**Section 96(1A) Modification Application (SSD 6078) MOD 6 – Oakdale Central, Horsley Park (Lot 21 in Deposited Plan 1173181)**

This Modification Application is submitted to the NSW Department of Planning & Environment (NSW DP&E) on behalf of Goodman Property Services (Aust) Pty Ltd and relates specifically to Lot 3 within the Oakdale Central Estate, Horsley Park.

**Figure 2: Proposed Layout - Lot 3**

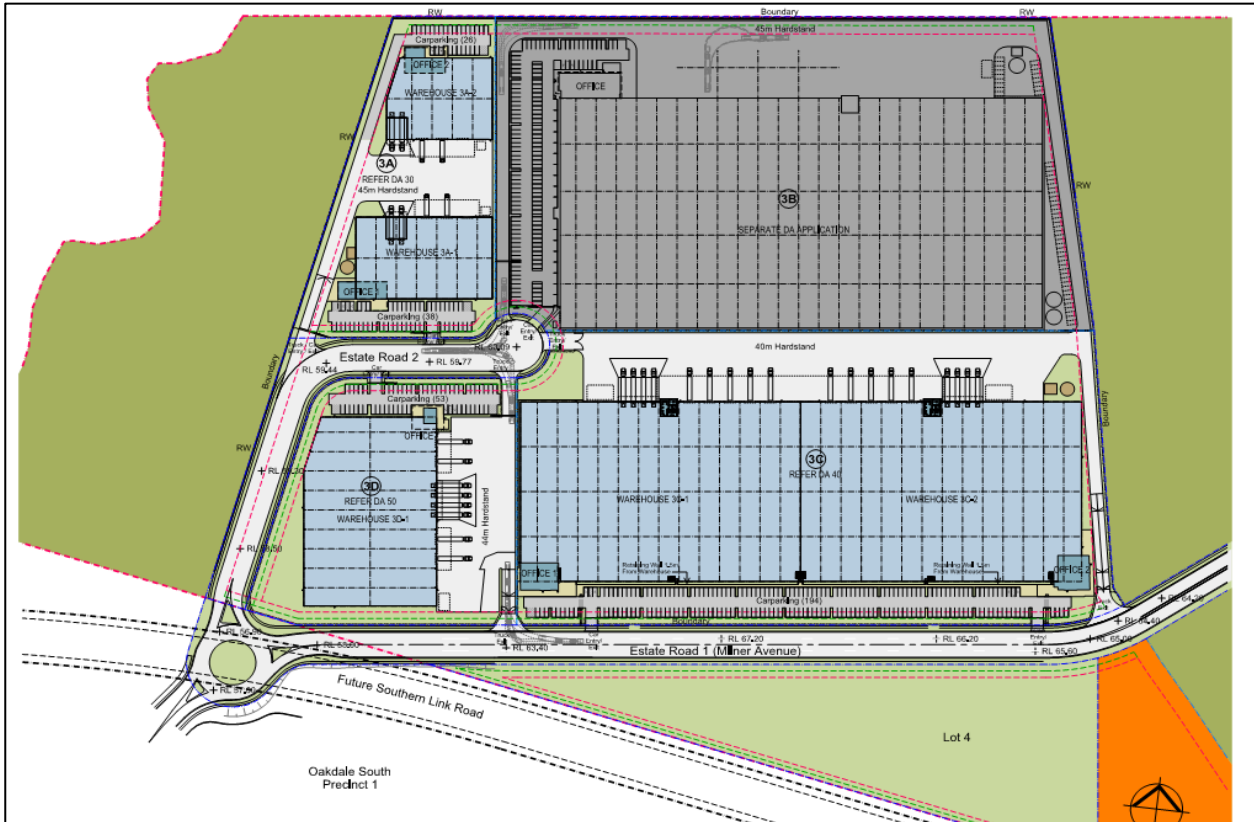
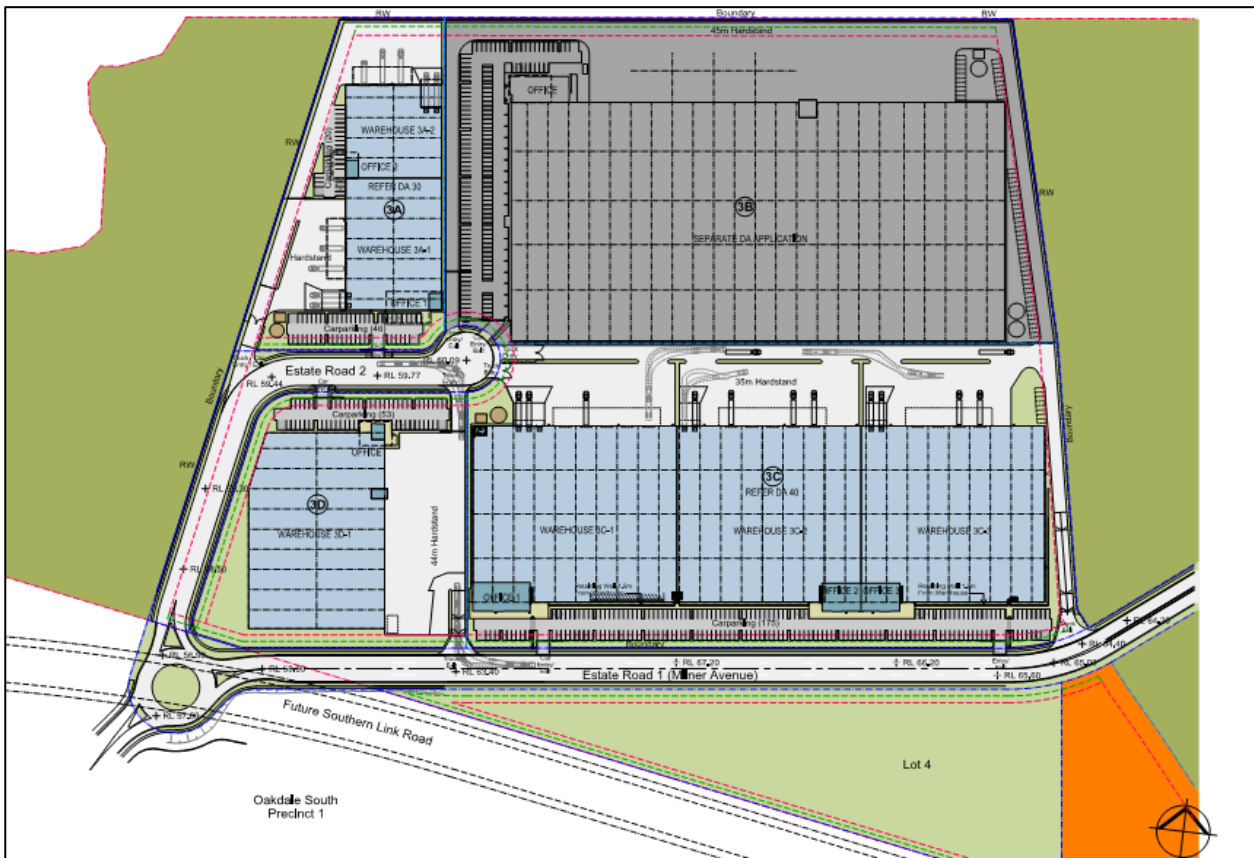
- Consolidation of Warehouse 3A from two separate buildings to a single building with dividing wall such that two separate tenancies, hardstand and car parking areas are maintained.
- Internal separation of Warehouse 3C to form three tenancies (previously two) and provision of separated hardstand area arrangements.

<b>Table 2: Schedule of Proposed Changes</b>		
<b>Project Element</b>	<b>Approved</b>	<b>Proposed under Section 96</b>
Warehouse	<p>Construction of warehouse facilities comprising:</p> <p><b>Lot 3A</b></p> <ul style="list-style-type: none"> <li>- Warehouse 1 (3,448sqm)</li> <li>- Office 1 (725sqm)</li> <li>- Warehouse 2 (2,515sqm)</li> <li>- Office (595sqm)</li> <li>- Car Parking (64)</li> </ul> <p><b>Lot 3C</b></p> <ul style="list-style-type: none"> <li>- Warehouse 1 (16,014sqm)</li> <li>- Office (566ssqm)</li> <li>- Dock Office (95sqm)</li> <li>- Warehouse 2 (16,095sqm)</li> <li>- Office (561sqm)</li> <li>- Dock Office (95sqm)</li> <li>- Car Parking (194)</li> </ul> <p><b>Lot 3D</b></p> <ul style="list-style-type: none"> <li>- Warehouse (7,975sqm)</li> <li>- Office (300sqm)</li> </ul>	<p>Modification to warehouses on Lot 3 as follows:</p> <p><b>Lot 3A</b></p> <ul style="list-style-type: none"> <li>- Warehouse 1 (3,825sqm)</li> <li>- Office 1 (550sqm)</li> <li>- Warehouse 2 (2,680sqm)</li> <li>- Office 2 (272sqm)</li> <li>- Car Parking (66)</li> </ul> <p><b>Lot 3C</b></p> <ul style="list-style-type: none"> <li>- Warehouse 1 (11,000sqm)</li> <li>- Office Level 1 (500sqm)</li> <li>- Dock Office 2 Levels (30sqm)</li> <li>- Warehouse 2 (9,690sqm)</li> <li>- Office 2 (500sqm)</li> <li>- Warehouse 3 (9,690sqm)</li> <li>- Office 3 (500sqm)</li> <li>- Car Parking (183)</li> <li>- Provisional Parking Spaces (8)</li> </ul> <p><b>Lot 3D</b></p> <ul style="list-style-type: none"> <li>- Warehouse (7,935sqm)</li> <li>- Office (300sqm)</li> <li>- Dock Office (50sqm)</li> <li>- Car Parking (53)</li> </ul>

The approved and proposed scheme for Lot 3 is provided in the below figures.
